4 Stories - Senior Living
17,608 SF -81 Units
2 Stories - Garage
99 Stalls

1 SD Site Plan
1/32" = 1'-0"

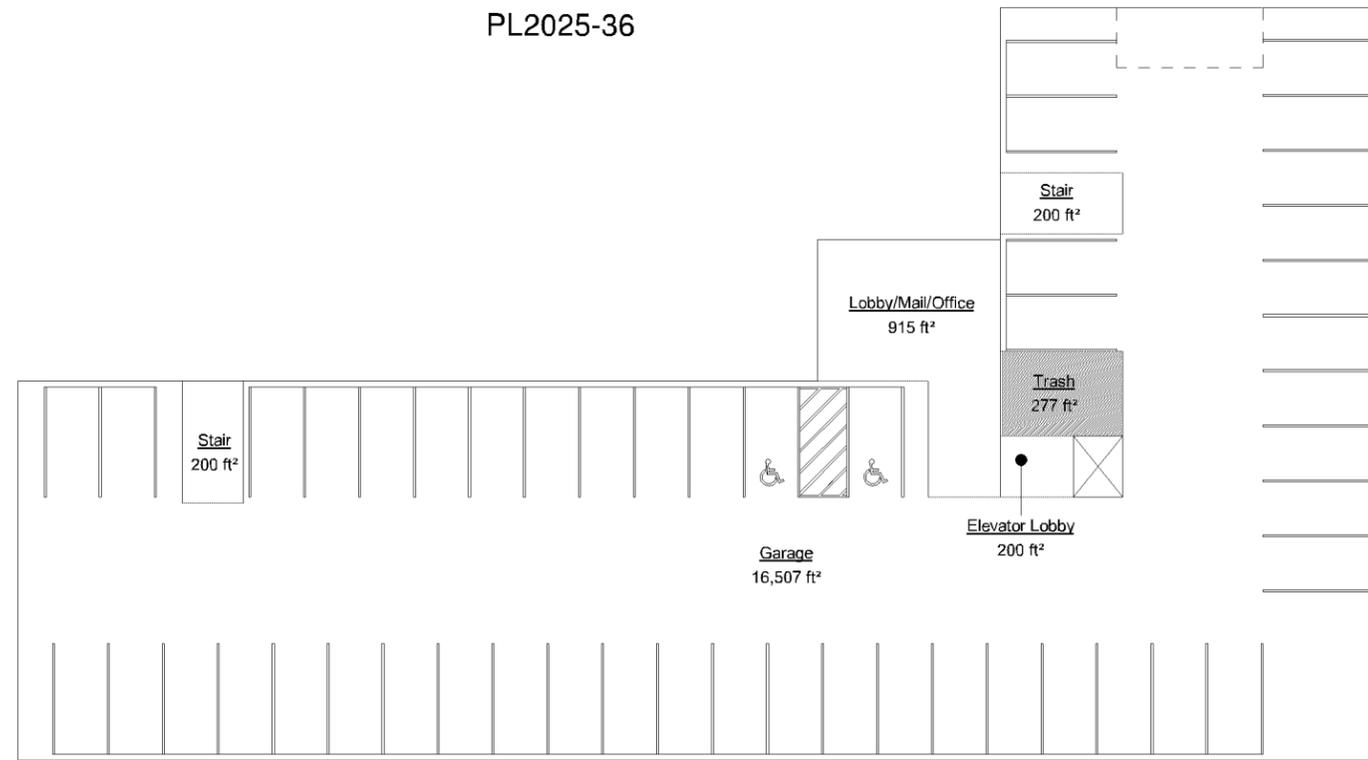
Hydrant coverage shall be provided within 50' of the FDC and within 150' of all portions of the structure.

Emergency responder radio coverage meeting the requirements of appendix P in the 2020 MSFC shall be provided throughout the property and within the structures.

Building/property shall be adequately signed for emergency response.

Ensure landscaping doesn't interfere with access to the building, hydrants and/or FDC.

Provide a sidewalk connection between the main entrance and the trail on the east side of the drive lane.

2 Level 2
 1" = 30'-0"

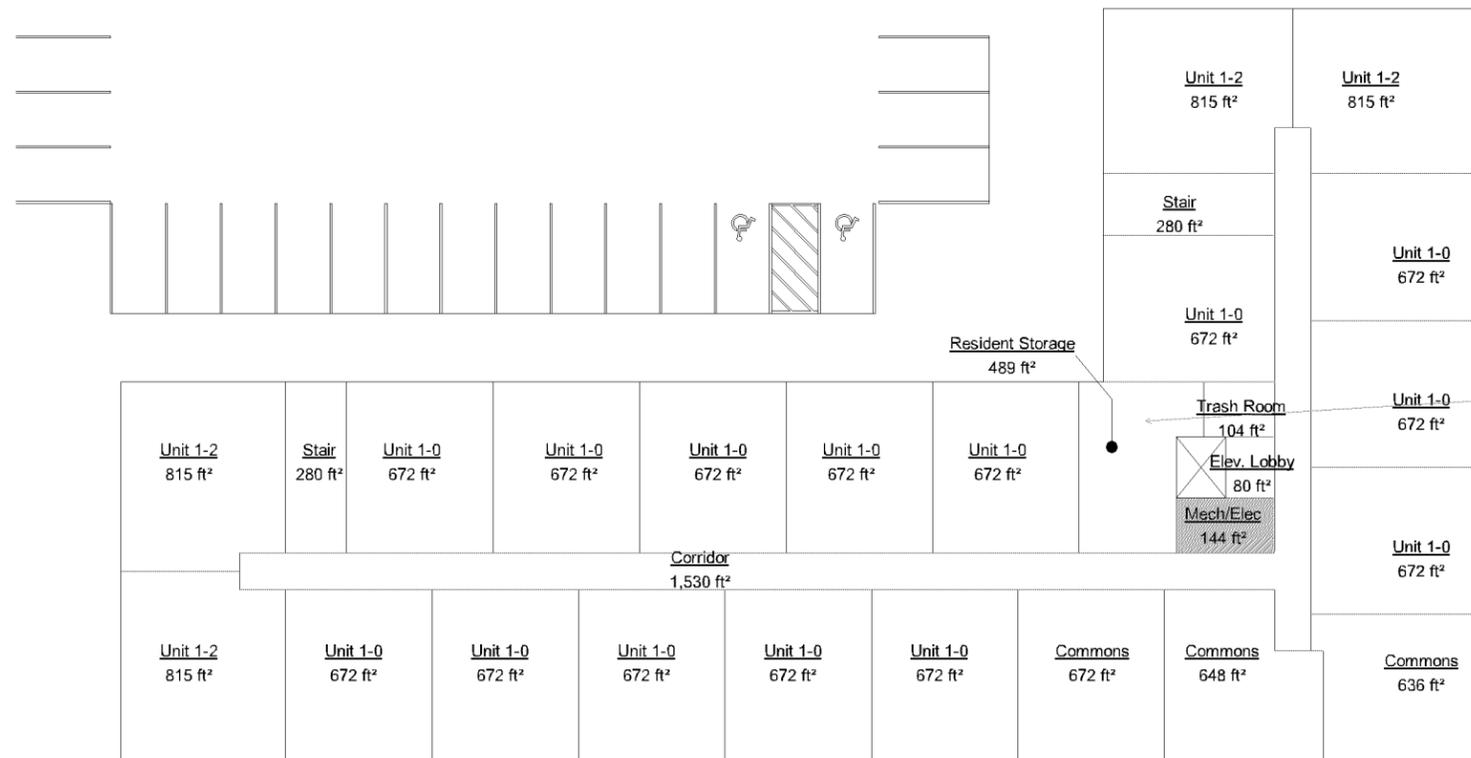
Senior housing is not subject to the storage unit requirement. That said, City Code does require adequate in-unit storage space. It may be prudent to incorporate storage units anyway.
